TITLE: 900M WIDE BAND RF MODULE			
DOC NO	DIVISION	TELCOM	
MODEL NO	900MRF	DRIVEN	CCIO
PART NO	CCIO	CCIO	CCIO
PAGE	1 OF 1	APPRO	
INTEGRATED DISPLAY TECHNOLOGY LTD.

TITLE: AT8900 BASE SCHEMATIC DIAGRAM FOR FTMS (25 Feb 2003)			
DOC NO	DIVISION	TELCOM	
MODEL NO AT8900	DRAWN Humanqng		
PARTNO	CHKD Xuhang		
PAGE 1 OF 1	APPD K.J.HAN		
 iBt INTEGRATED DISPLAY TECHNOLOGY LTD.

TITLE:			
900M WIDE BAND RF MODULE			
DOC NO	DIVISION	TELCOM	
MODEL NO	SCOURF	DRAWN	CCXO
PART NO		CHKD	CCXO
PAGE	1 OF 1	APPRO	
INTEGRATED DISPLAY TECHNOLOGY LTD.

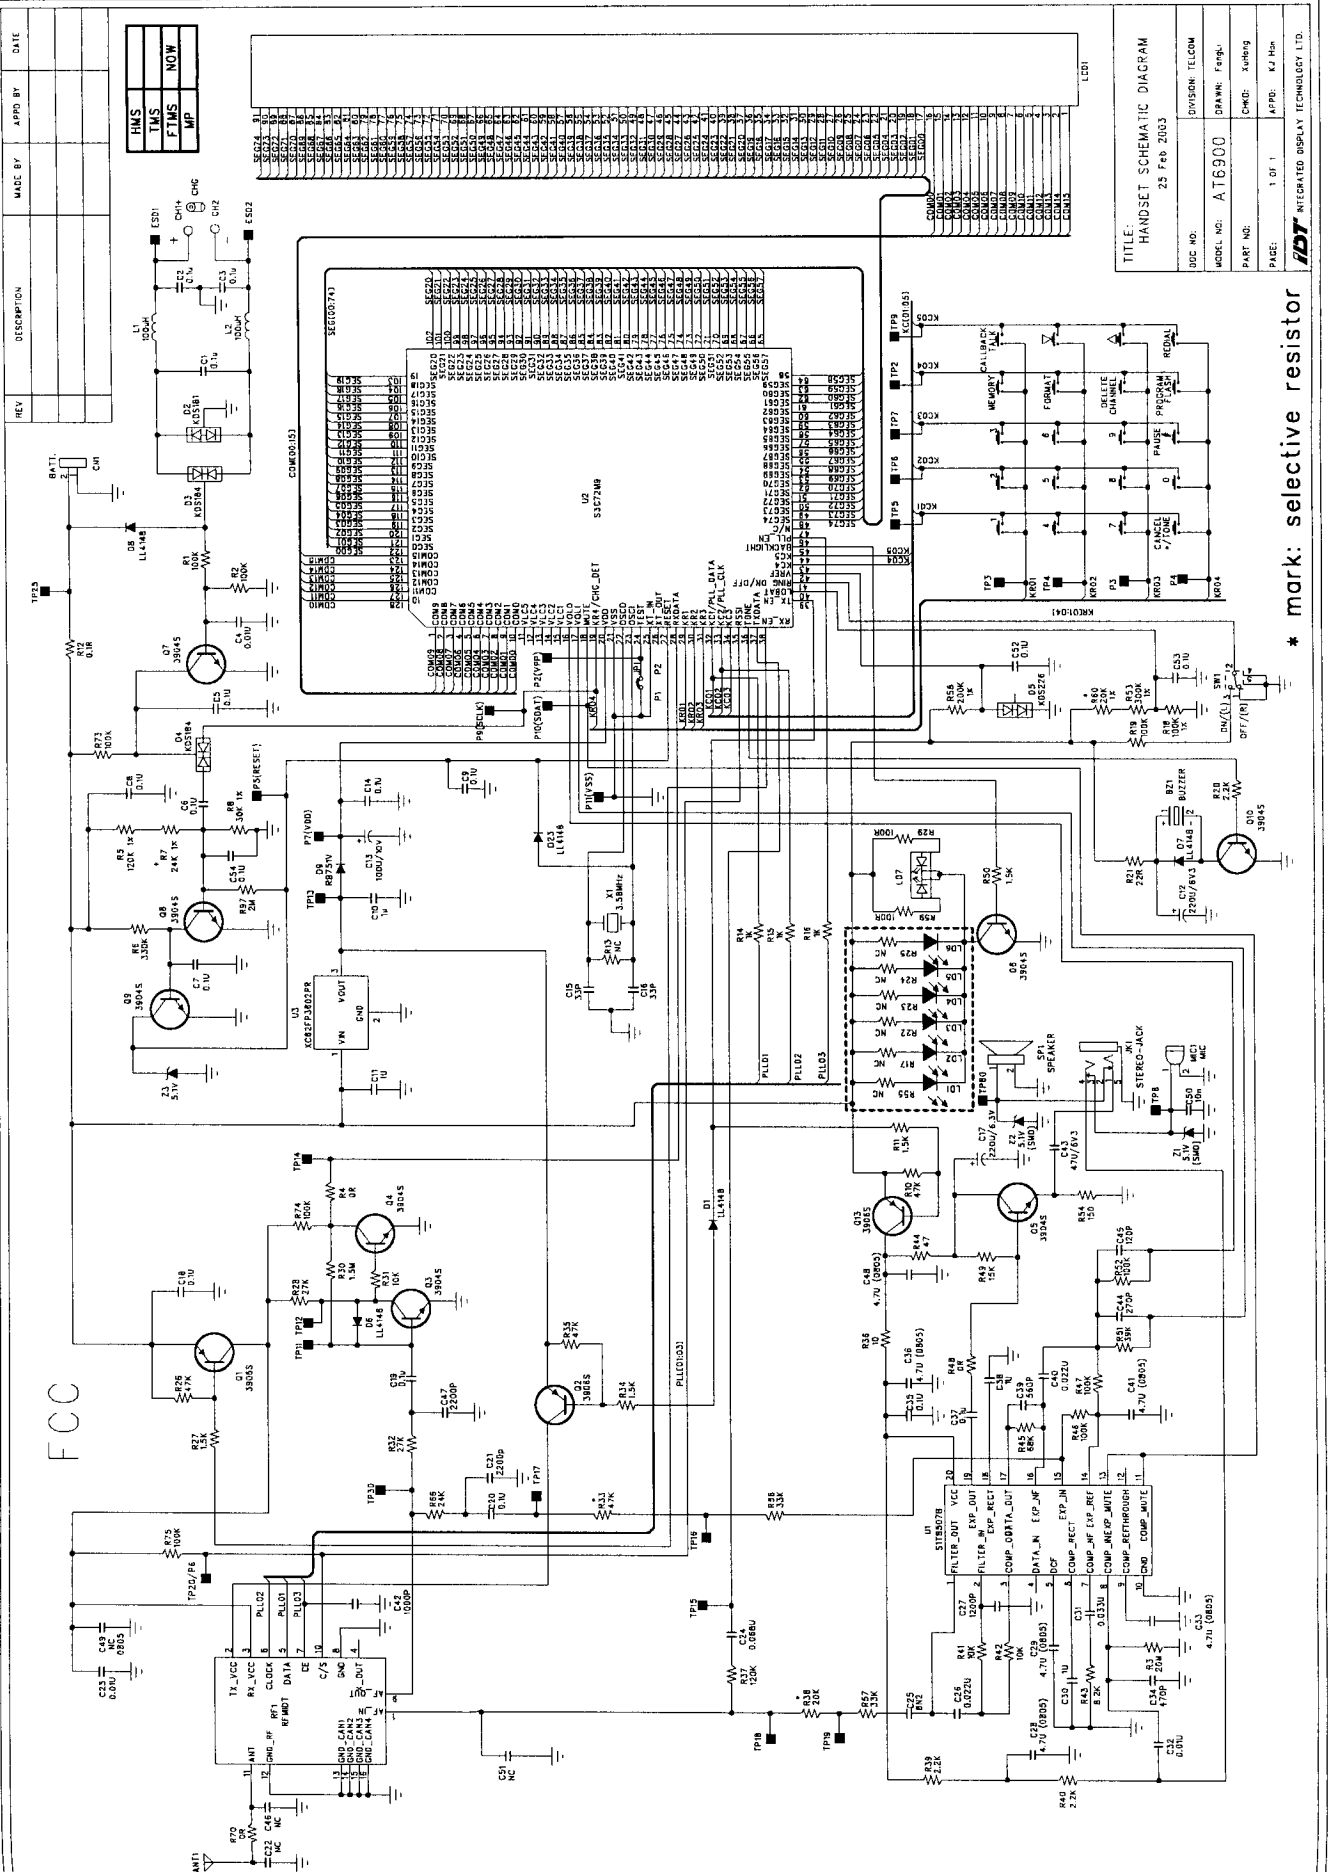
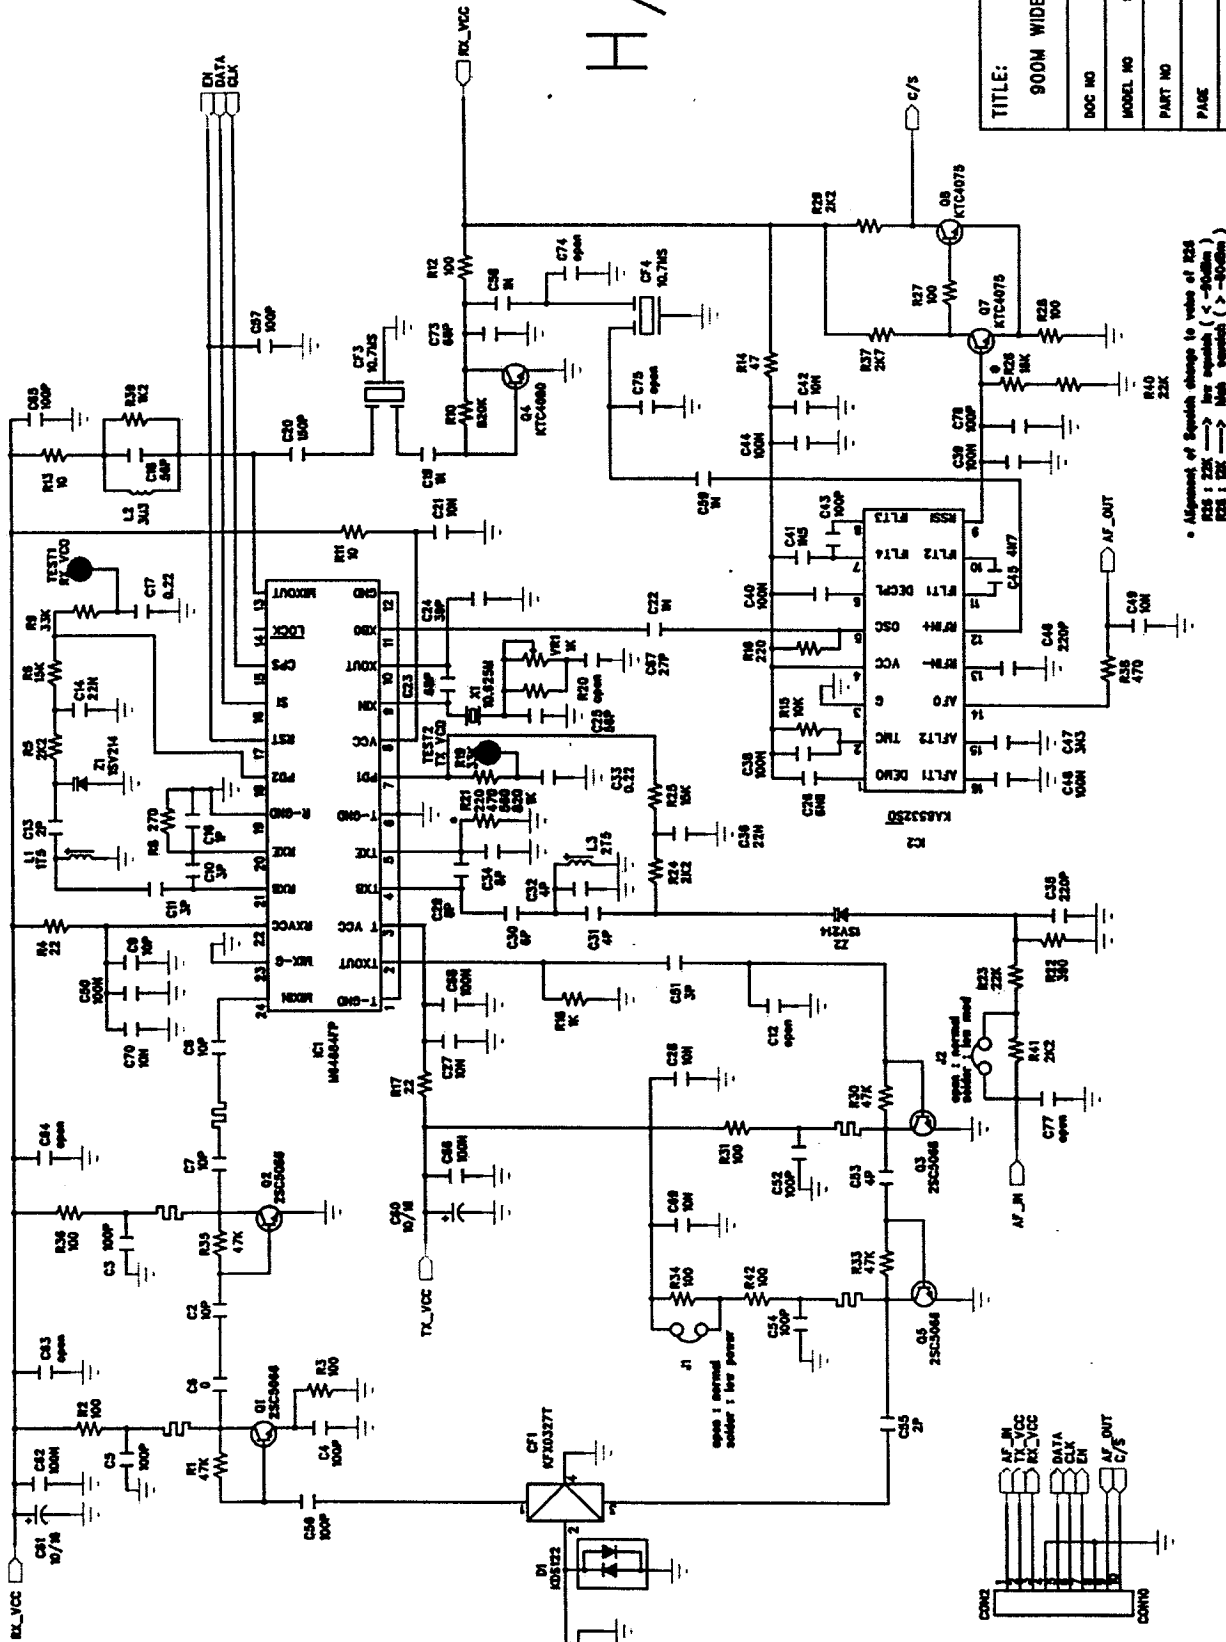
Alignment of Spanish change to value of R25
R25 : 22K → for Spanish (< -50dBm)
R28 : 22K → for Spanish (> -50dBm)

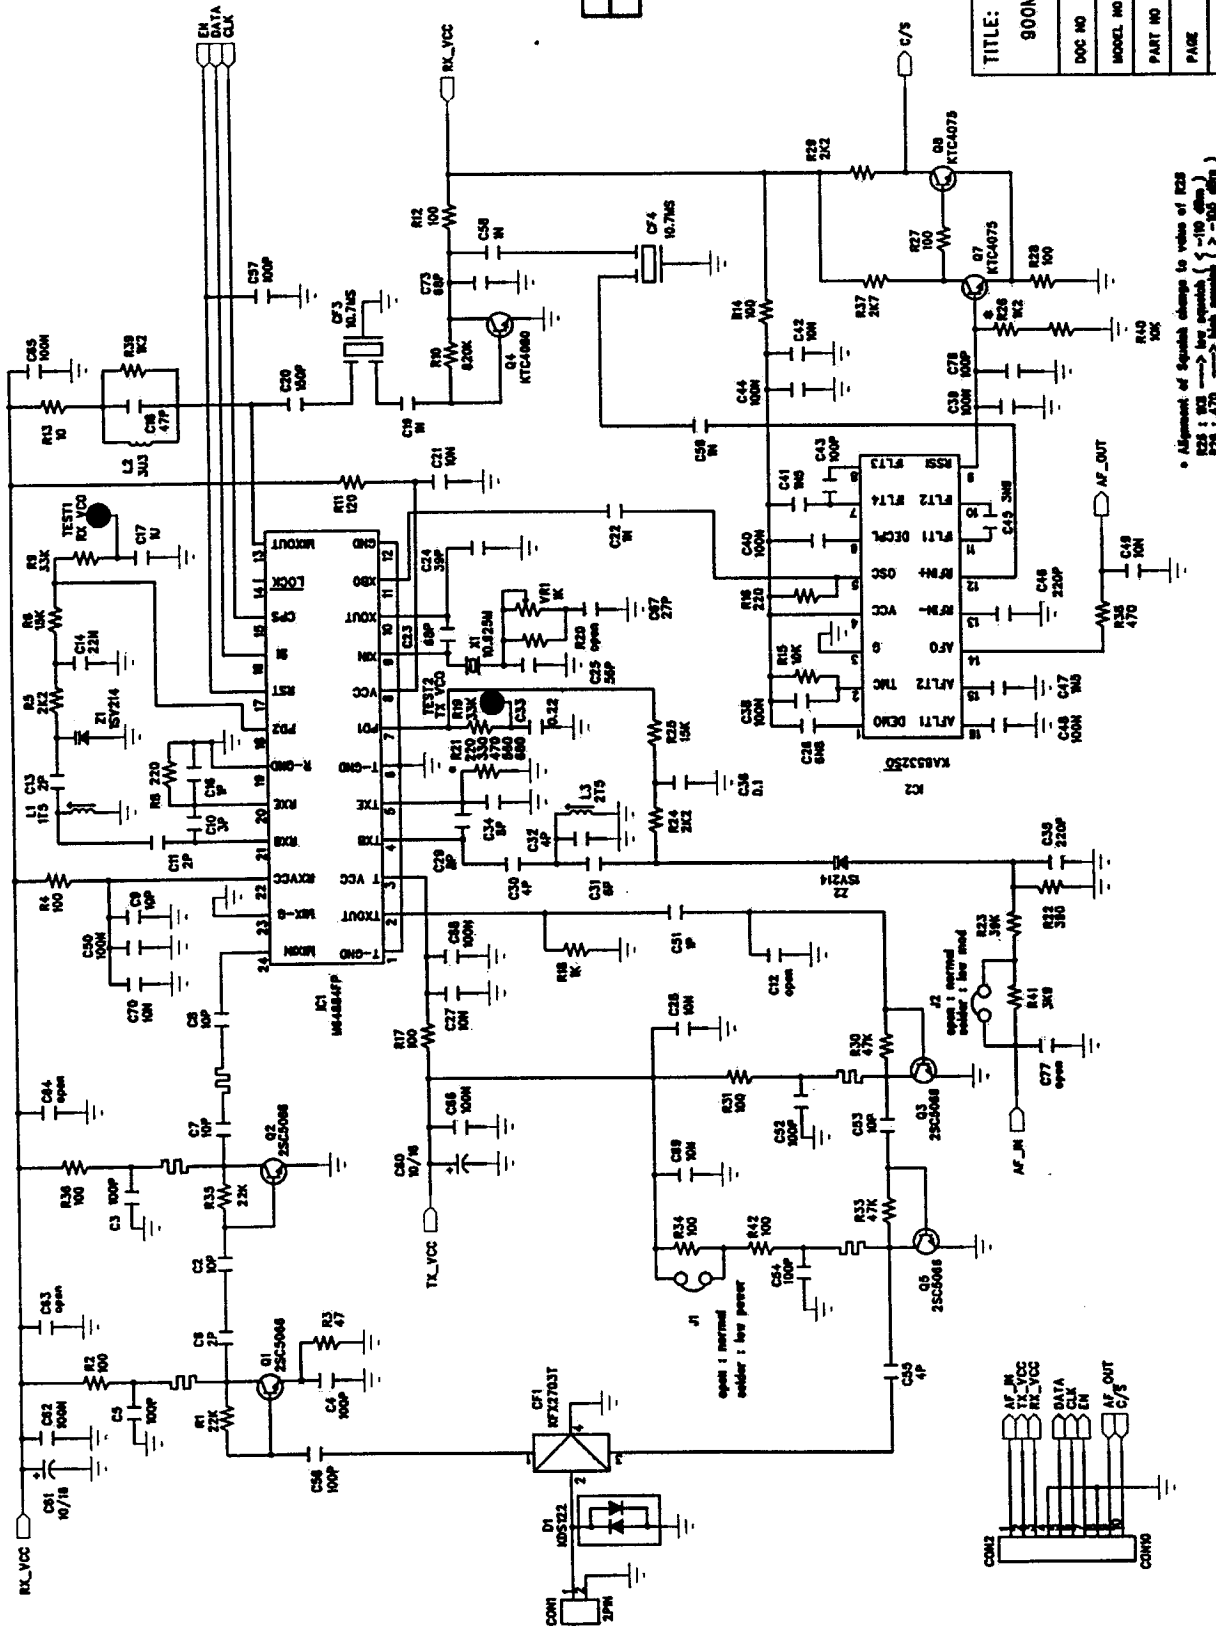
Alignment of Squelch change to value of R28
R28 : R23 -> low squelch (< 100 Ohm)
R28 : 470 -> high squelch (> 100 Ohm)
